SUBJECT: FLAW EVALUATION GUIDELINES

DISPOSITION OF TECHNICAL COMMENTS
IN ENCLOSURE 1 TO NEI LETTER
DATED OCTOBER 22, 2001

FLAW EVALUATION GUIDELINES

Figure 1

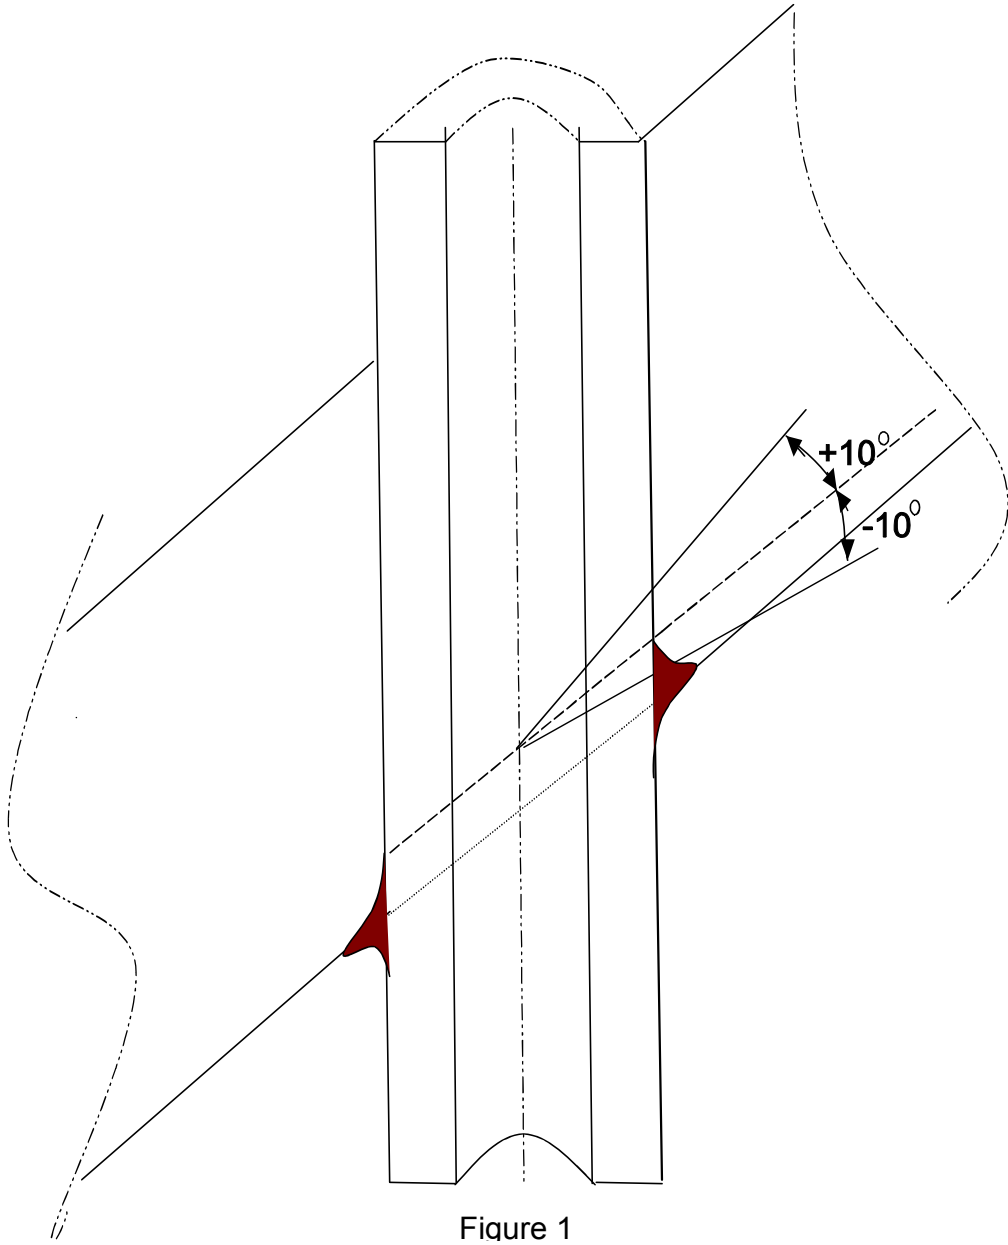
- The proximity rules of ASME Code Section XI for considering flaws as separate may be used (Figure IWA 3400-1, attached).
- When a flaw is detected, its projections in both the axial and circumferential directions shall be determined. Note that the axial direction is always the same for each nozzle head penetration, but that the circumferential direction will vary depending on the angle of intersection of the penetration with the head. The circumferential direction of interest is along the top of the attachment weld as illustrated in Figure 1. It is this angle along which separation of the nozzle penetration from the head could occur.

- Flaws that are equal to or greater than 45-degrees from the vertical centerline of the CRDM nozzle, or those that are within plus or minus 10-degrees of the angle (if less than 45-degrees) that the plane of the partial-penetration attachment weld (J-groove weld) makes with the vertical centerline of the CRDM nozzle, are considered to be circumferential flaws.
